ADDENDUM

Project:	Ft. Branch HVAC Phase 4 7670 S. Eastview Lane Ft. Branch, IN 47648	Addendum No.:	002
		Date:	January 8, 2021
Owner:	South Gibson School Corporation 3321 800 S. Ft. Branch, IN 47648	Project Number:	2011-314
		Contract for:	All

Ft. Branch Community School
HVAC Upgrades - Phase 4

LIGHTING PLAN ADD-02

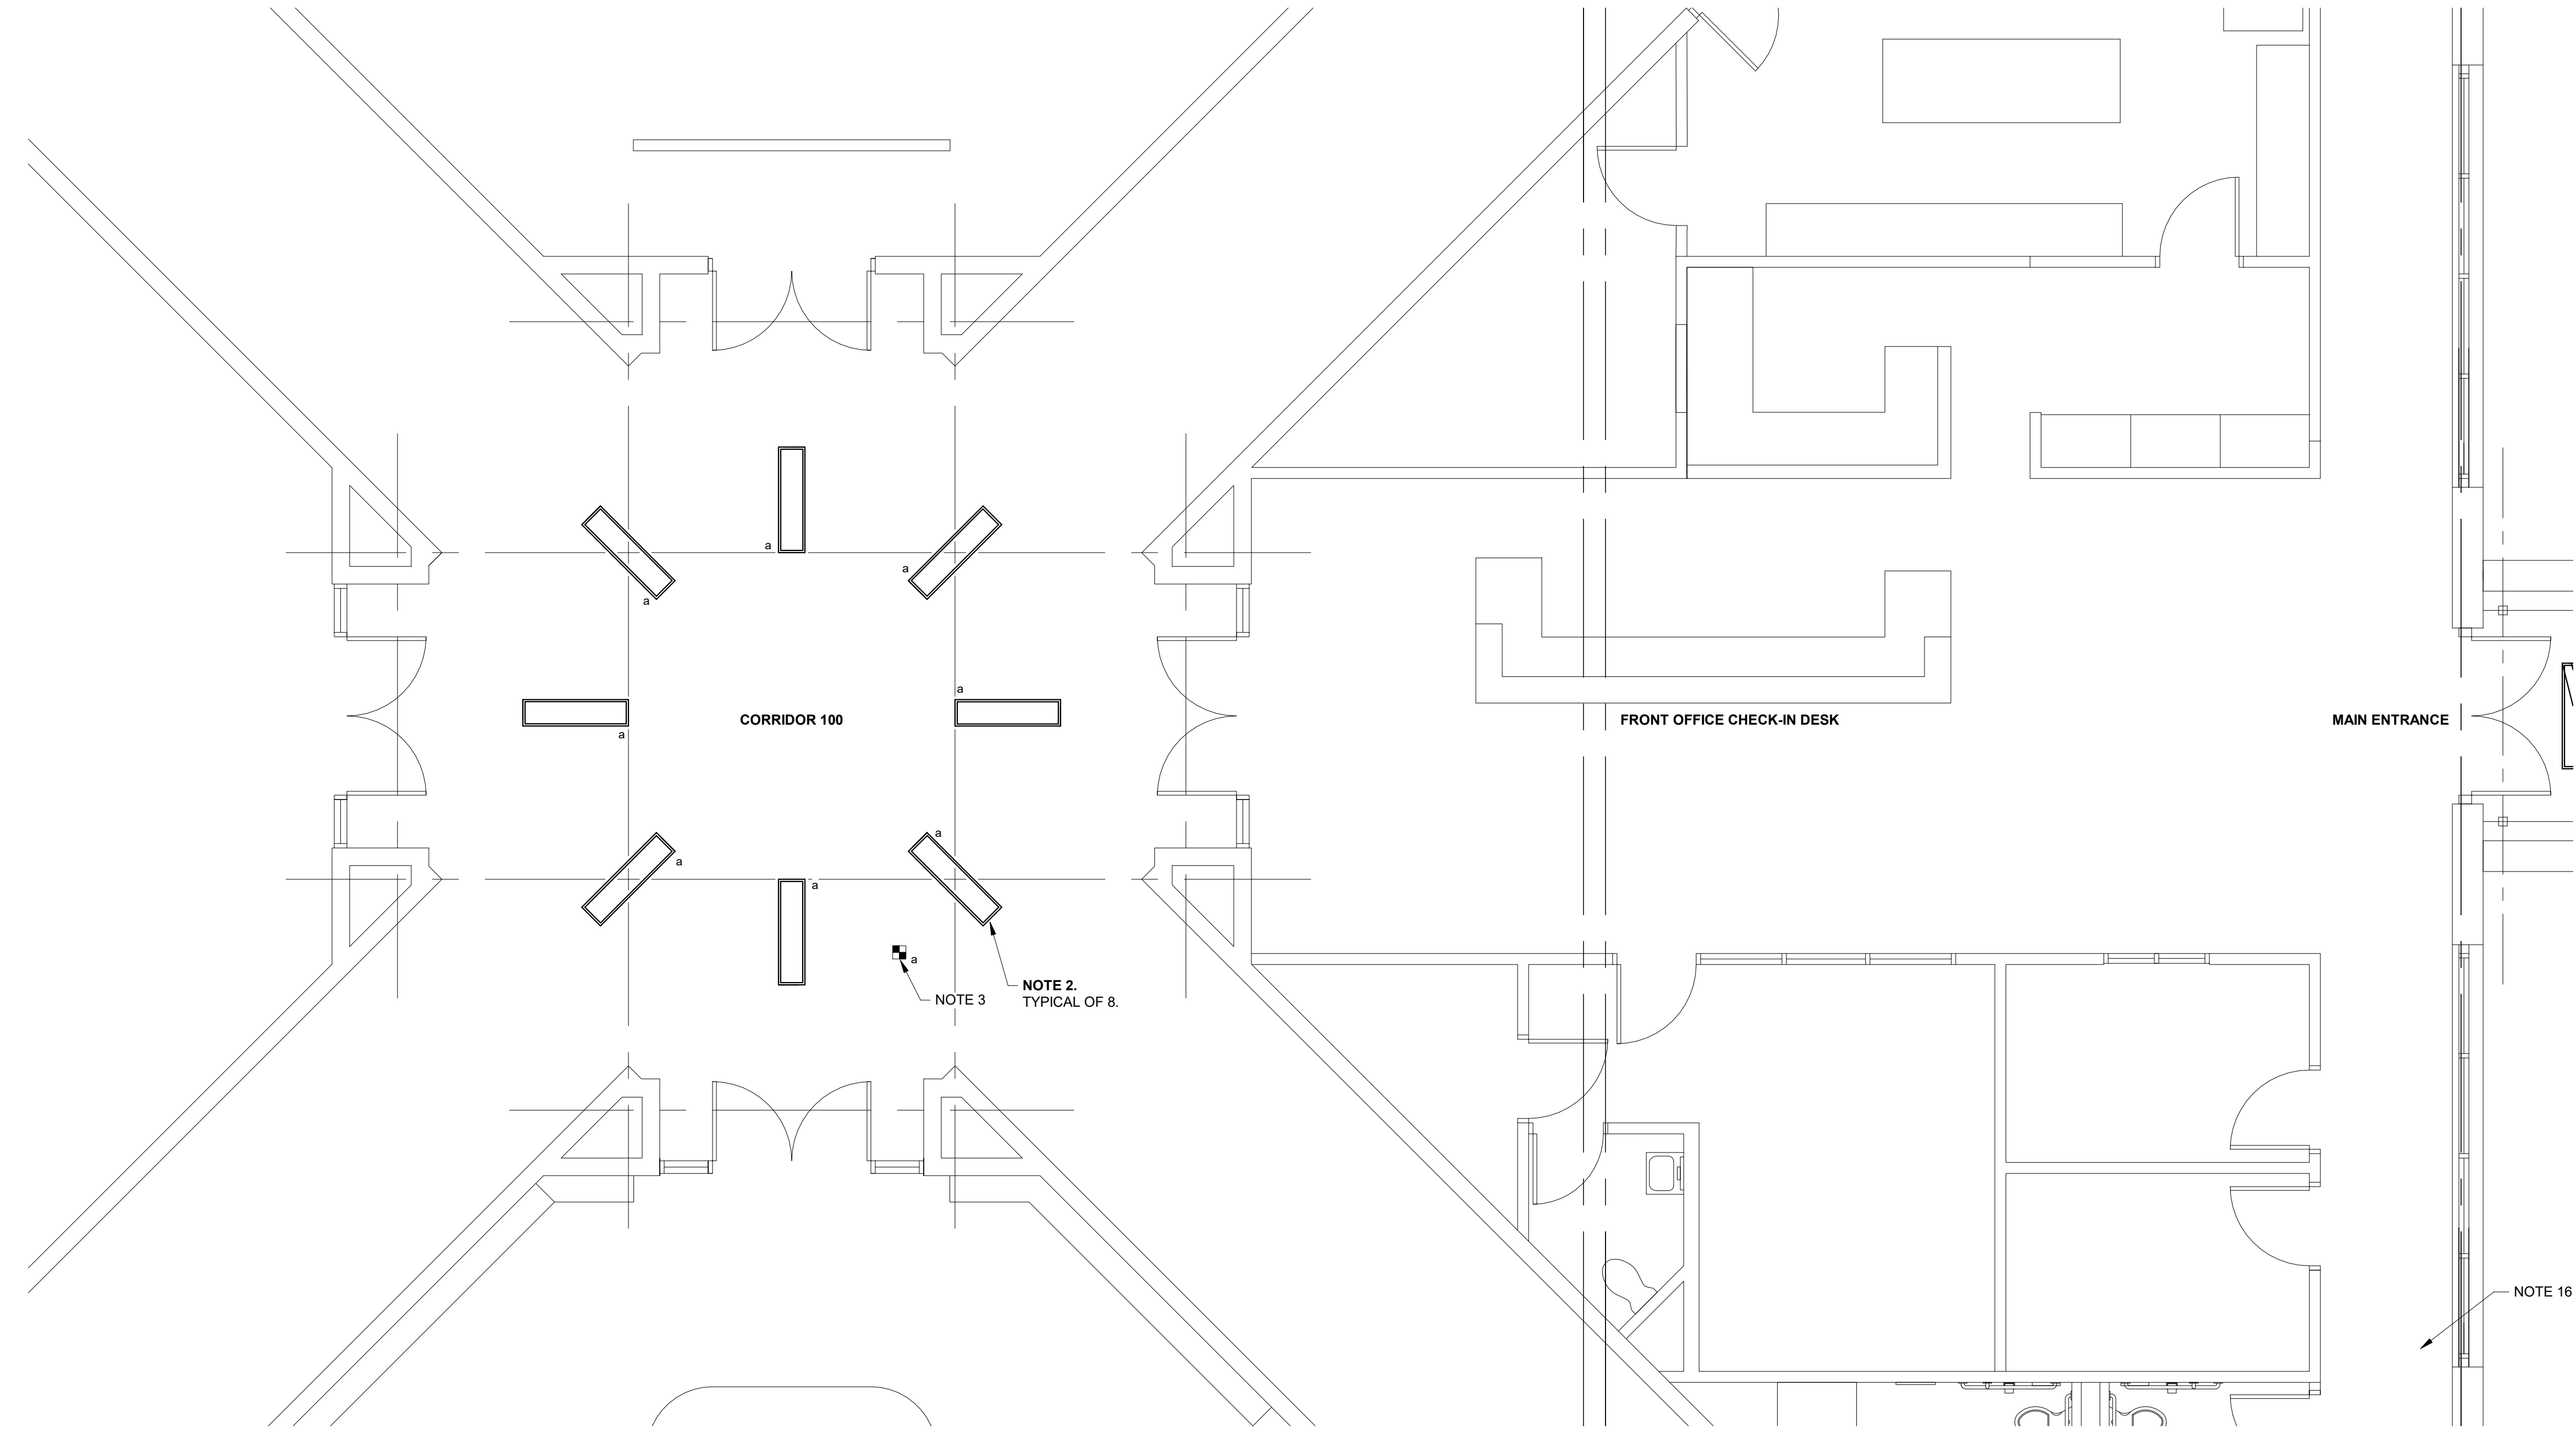
- 1-1 Labor and Material to disconnect and remove existing light fixtures above Corridor 100. Provide eight 4' LED light fixtures. Surface mount light fixtures in same location as demolished light fixtures. Connect light fixtures to existing light circuit serving light fixtures as was before demolition. Light fixture shall be 48" LED in white housing surface mounted. Fixture color shall be 3500 kelvin, multi-volt range(120-277V), and have a lumen output of 4000. Fixture shall have a wide diffuse lens and accessories to surface mount. Manufacturer and model shall be Lithonia CLX series or equal. Provide dimmer switch above ceiling to control light level of the eight light fixtures. Refer to sheet ADD-02 for additional requirements.

1. DISCONNECT AND REMOVE POWER FEED TO LIGHT FIXTURE. REMOVE LIGHT FIXTURE. LIGHTING CIRCUIT TO REMAIN FOR REUSE.
2. PROVIDE ALL LABOR AND MATERIAL TO CONNECT LIGHT FIXTURE TO EXISTING LIGHT CIRCUIT AS WAS BEFORE DEMOLITION. FIXTURES SHALL OPERATE WITH TIME SCHEDULE THROUGH BAS SYSTEM IN BUILDING. COORDINATE WITH OWNER TO DETERMINE THE CORRECT SCHEDULE FOR LIGHT FIXTURES TO OPERATE. CONTRACTOR SHALL BE RESPONSIBLE FOR CORRECT OPERATION OF FIXTURES.
3. PROVIDE DIMMER ABOVE CEILING TO CONTROL LIGHT LEVEL OF FIXTURES SHOWN. PROVIDE ALL LABOR AND MATERIAL TO MOUNT DIMMER IN ACCESSIBLE LOCATION. COORDINATE WITH ONSITE MAINTENANCE, JEFF CRECELIUS, FOR EXACT LOCATION.
